## Planning Commission Issues Report

**Subject:** Zoning Map Amendment  
**Meeting Date:** May 23, 2016  
**From:** Jonathan Raiche, Senior Planner  
**Location:** South side of Interstate 64 east of Chesterfield Commons Drive  
**Petition:** **P.Z. 11-2015 Kemp Auto Museum (16861 Chesterfield Airport Road)**

**RE: PZ 11-2015 KEMP AUTO MUSEUM (16861 CHESTERFIELD AIRPORT RD)**

**PP**  
PRELIMINARY PLAN

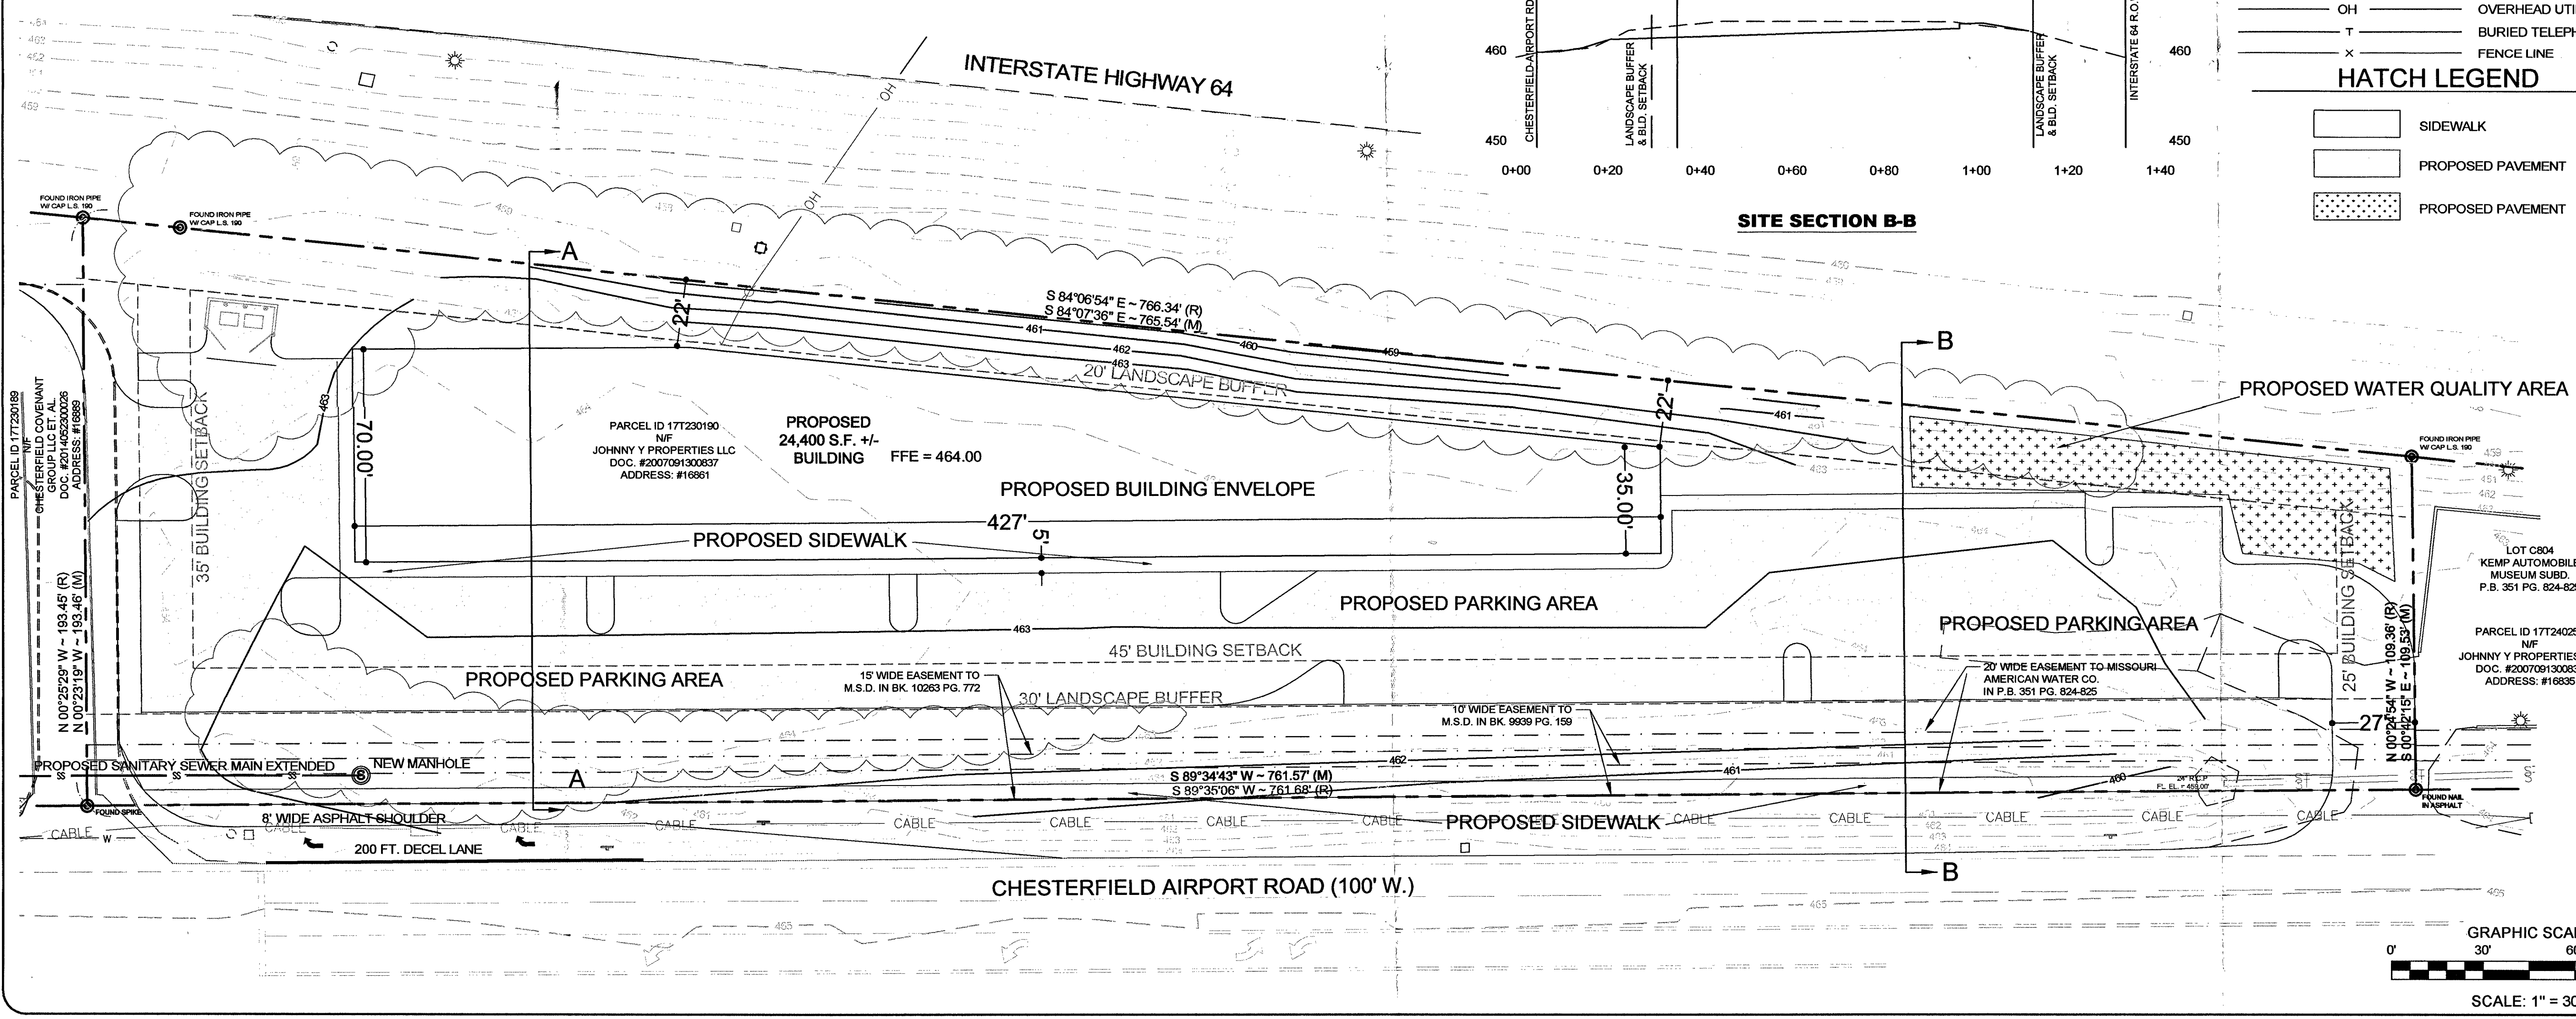
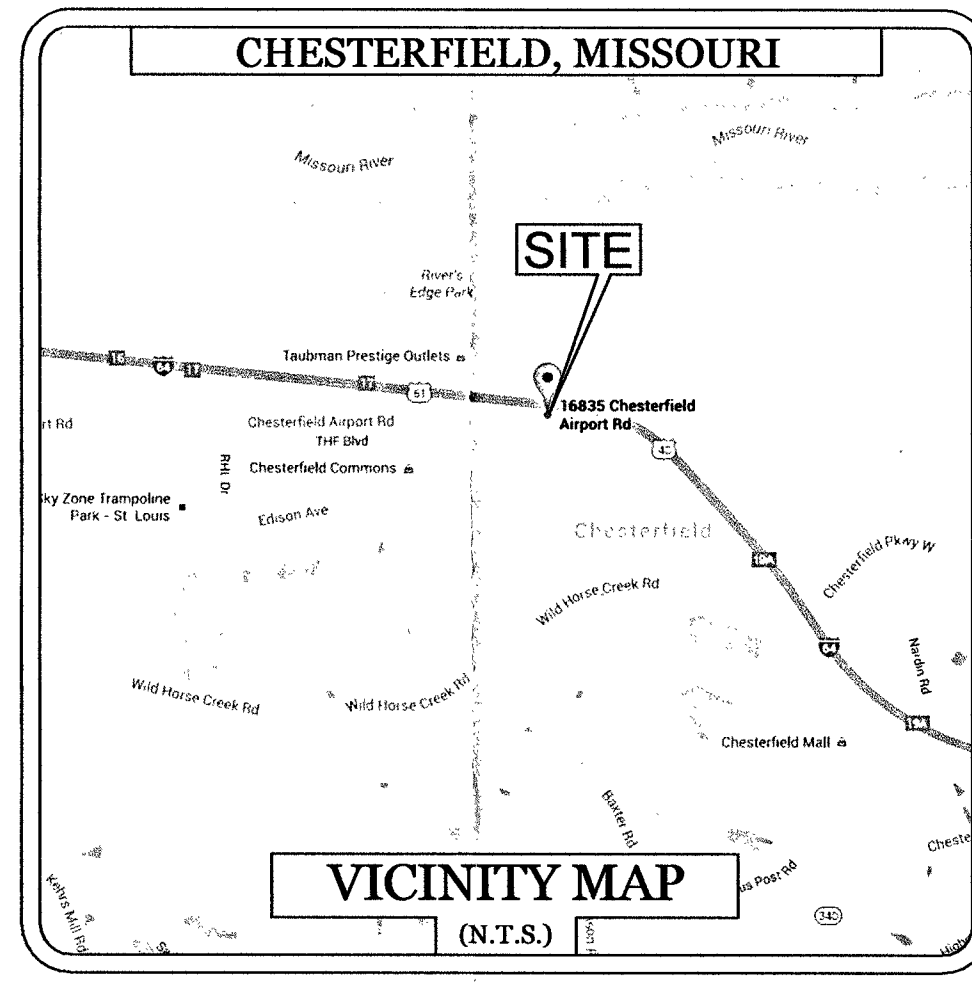
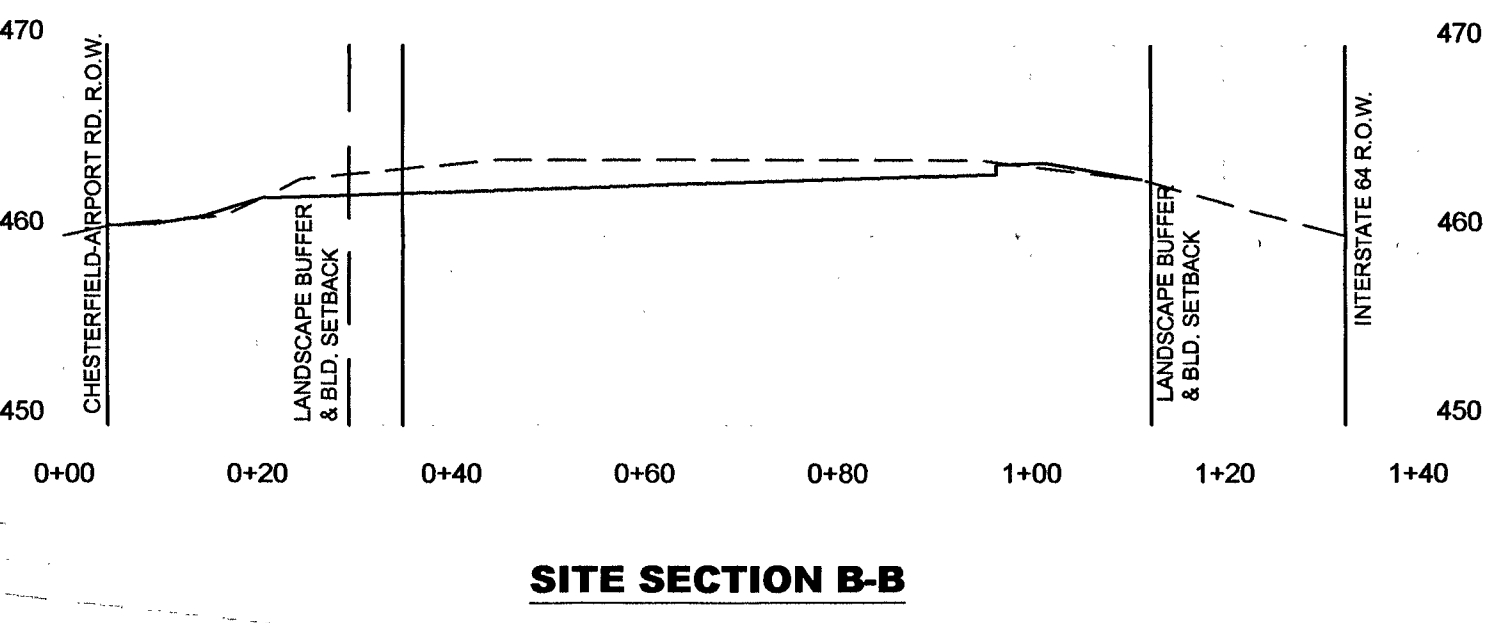
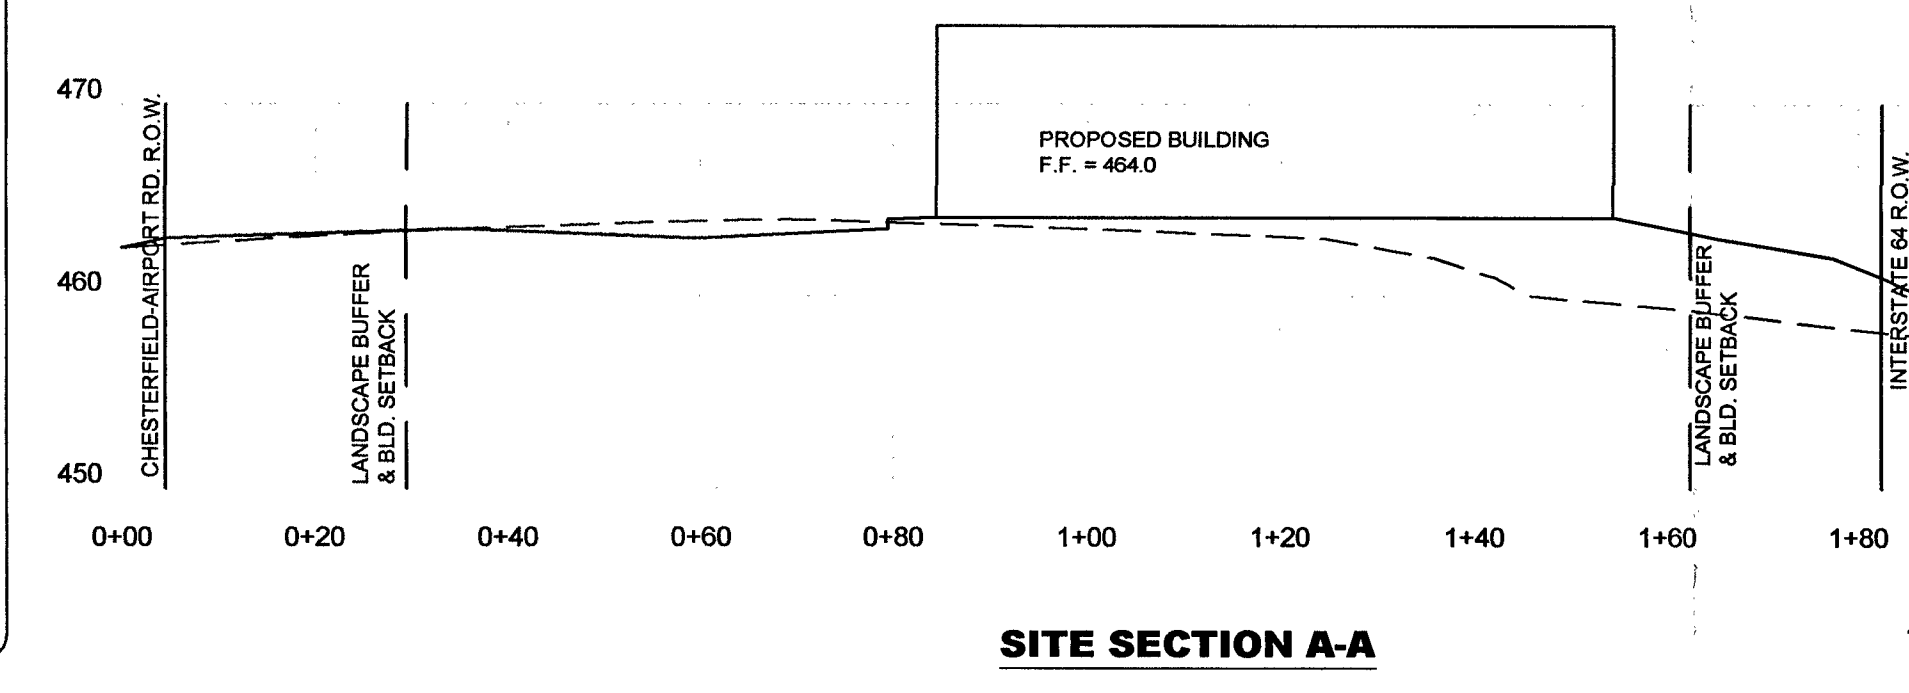
1. The Preliminary Plan shows only measured survey information, but the written legal description is based on recorded information. Please include the recorded survey information on the drawing and denote each as "Measured" or "Recorded" as mentioned in Notes 4 and 5.

entrance will be widened and will be partially located on this property. Access easements were granted and recorded between 16689 and 16861 Chesterfield Airport Road in Book 21506 Page 2445. Please review the access easements and see the attached Improvement Plan sheet for 16889 Chesterfield Airport Road and update this Preliminary Plan accordingly.

3. Align the proposed western internal drive connection to be directly across from the internal parking lot entrance on 16689 Chesterfield Airport Road.

4. Review the width of the eastern entrance drive from Chesterfield Airport Road. The minimum entrance drive width is 24 feet. Revise as necessary.

5. Include a 5' sidewalk along Chesterfield Airport Road.

6. Indicate the proposed area for water quality stormwater features.

7. Preliminary sanitation and drainage facilities are required on the plan. Revise the plan to include both existing and proposed sanitary and storm sewers.

8. Include a note on the plan that slopes shall not exceed 3 horizontal to 1 vertical.

9. Two section profiles are required on the Preliminary Plan. Staff recommends that the sections be provided at each end of the building.

10. Include the names of the property owners for the subject site and for adjacent parcels.

11. Expand the existing improvements shown on the plan to include the internal drive access on the property to the west.

12. Provide the maximum requested building height in feet. It is currently provided as two stories; however, actual height of stories can vary. Once the actual maximum requested height is noted, also adjust the sections to indicate the building's requested maximum height.

13. Open Space required for a Planned Commercial District is 35%. Revise note 22 to reflect this and confirm that 35% Open Space is being met on the plan. If this cannot be met, a separate Request for Modification of Standards shall be submitted. This request will require a separate 2/3 vote of the Planning Commission.

14. List the Floor Area Ratio on the plan. The maximum Floor Area Ratio for the site is 0.55.

15. Remove the references to the landscape buffer from the setbacks in General Note 3. While the structure setbacks cannot be less than the required landscape buffer, they are separate requirements.

16. Structure setbacks should be consistent with the building envelope shown. The current structure setbacks are not as restrictive as the building envelope indicates.

17. Be advised, your plan indicates a landscape buffer along the east and west property lines; however, there is no city requirement for this.

18. Label all easements shown on the plan. Specifically there appear to be multiple easements along the southern property line that are not labeled.

19. Remove the required parking numbers from the Preliminary Plan. This is dependent on the tenants proposed and will be dictated during the Site Development Plan process. All future tenants will be required to meet the minimum parking required by city code.

**A revised Preliminary Plan is submitted with this correspondence.**

**A revised Preliminary Plan is submitted with this correspondence.**

**A revised Preliminary Plan is submitted with this correspondence.**

**A revised Preliminary Plan is submitted with this correspondence.**

**A revised Preliminary Plan is submitted with this correspondence.**

**A revised Preliminary Plan is submitted with this correspondence.**

**A revised Preliminary Plan is submitted with this correspondence.**

**A revised Preliminary Plan is submitted with this correspondence.**

**A revised Preliminary Plan is submitted with this correspondence.**

**A revised Preliminary Plan is submitted with this correspondence.**

**A revised Preliminary Plan is submitted with this correspondence.**

**The maximum building height requested is 35 feet above finished grade exclusive of mechanicals.**

**A revised Preliminary Plan is submitted with this correspondence.**

**A revised Preliminary Plan is submitted with this correspondence.**

**A revised Preliminary Plan is submitted with this correspondence.**

**Petitioner requests that current structure setbacks be maintained. The building envelope shown is conceptual only and may change.**

**A revised Preliminary Plan is submitted with this correspondence.**

**All easements on the revised Preliminary Plan have been labeled as shown on the survey.**

**A revised Preliminary Plan is submitted with this correspondence.**
